Access Compliance Report Public Rights-of-Way (Curb Ramps)

Main Street: MILNEBURG_ST Cross Street: FARNHAM_LN Location: NE

ADA ID: RPAT220203105436 Ramp Type: Type 4 - Parallel Initial Pass/Fail: Fail Overall Compliance: No Severity Score: 5

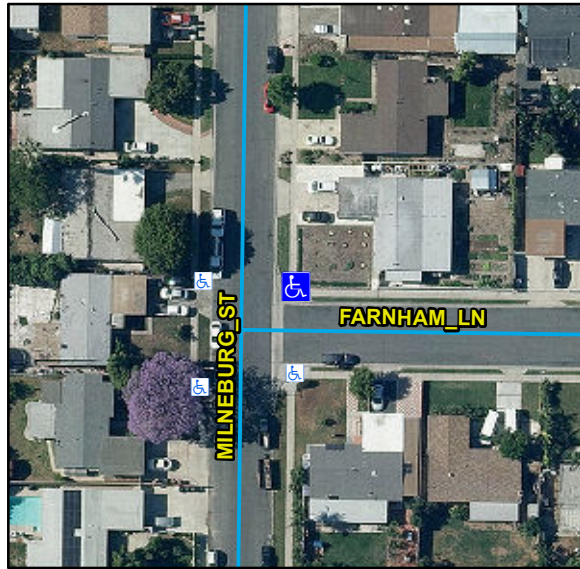
R304.5.1, R304.5.3, STD 1115

Remove & Replace Curb Ramp With Two New Directional Ramps or Equivalent.
